CERTIFICATE OF APPROPRIATENESS

Property: 835 Columbia Street, Lots 2& 3, Block 250, Houston Heights Subdivision. The property includes a 2,429 square foot, two-story wood frame single-family residence and detached garage situated on a 13,200 square foot (100' x 132') double interior lot.

Proposal: New Construction – Residence/Garage

The proposed new 3,758 square foot 1½ story residence and new rear detached two-story 1,219 square foot garage was deferred in February 2016 and denied in March 2016 by the HAHC for exceeding typical width due to an architecturally incompatible side extension. The applicant has now redesigned the house so that the side extension has been removed. Extra living space has been added at the very rear of the house instead.

SITE PLAN

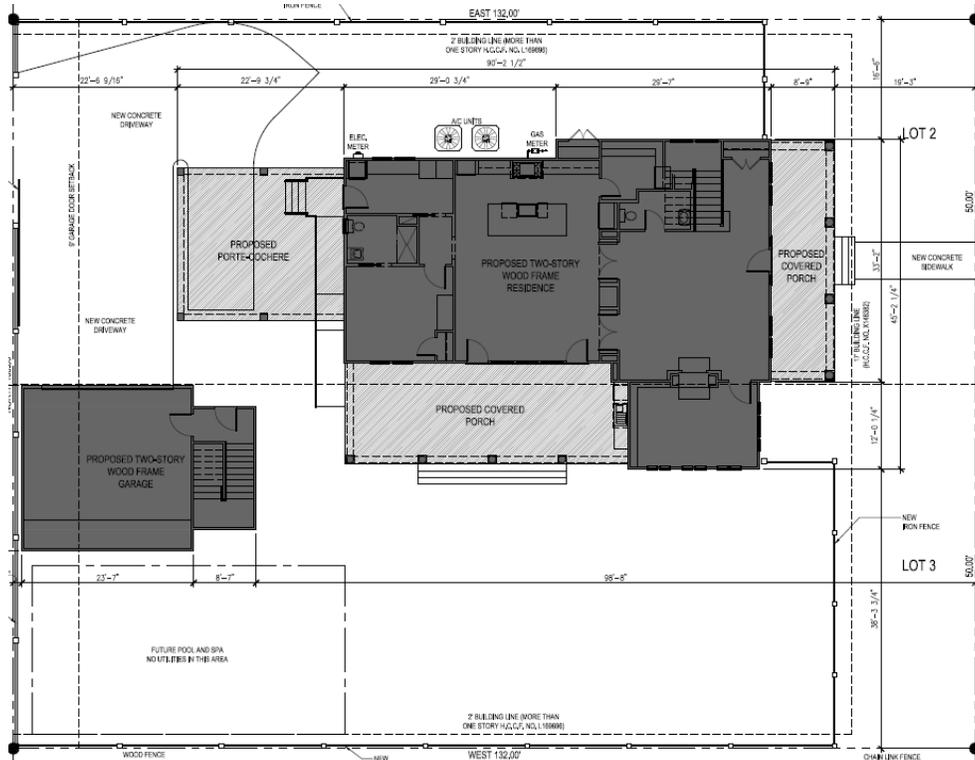
There is a Minimum Building Line ordinance on this block that requires a minimum setback of 17'. The front setbacks of the contributing structures on the blockface range from 6' to 30', with 10 out of the 13 having a front setback between 17'-20'. The proposed front setback of 19' is within this typical range. The proposed side setbacks for the house are 16.5' and 38', also compatible.

EAST ELEVATION – FRONT FACING COLUMBIA STREET

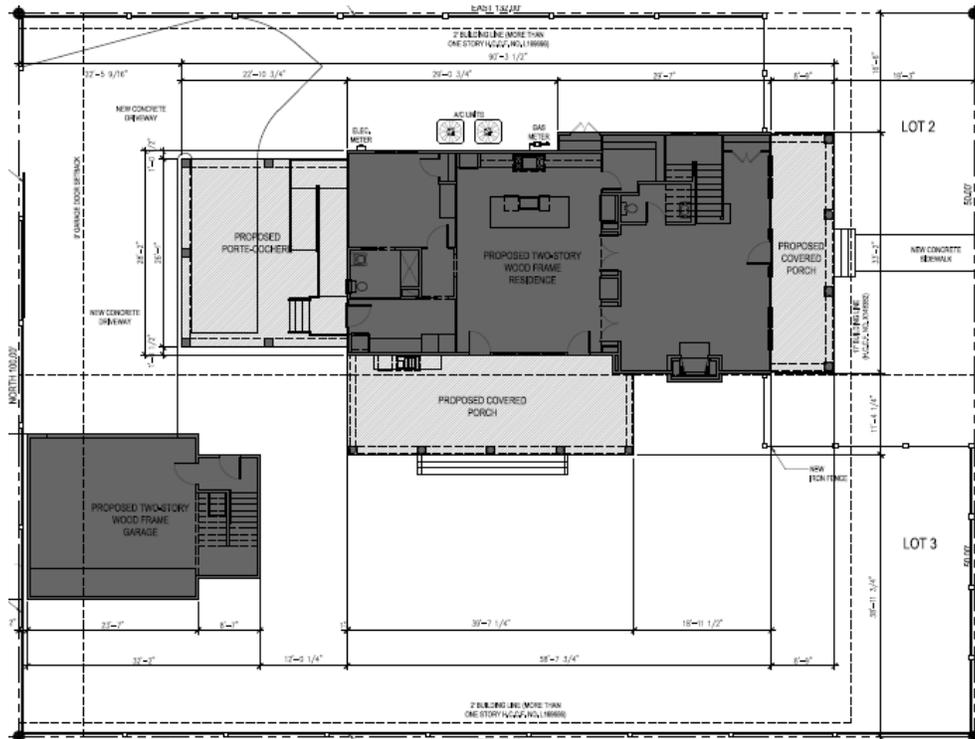
The proposed new residence with the south side extension had a total width of 45' that was not in scale with the contributing structures in the context area. Typical width ranges from 26' to 32' on the blockface. The removal of the 12' wide extension brought the front width of the residence to 33', which is compatible with widths on the blockface.

Staff requested updated drawings without the side extension to determine if the side porch had a significant visual impact on the residence. Staff has determined that the visual impact is minimal based on the transparency of the porch and the location at approximately 28' from the front. Therefore, the project meets this criterion.
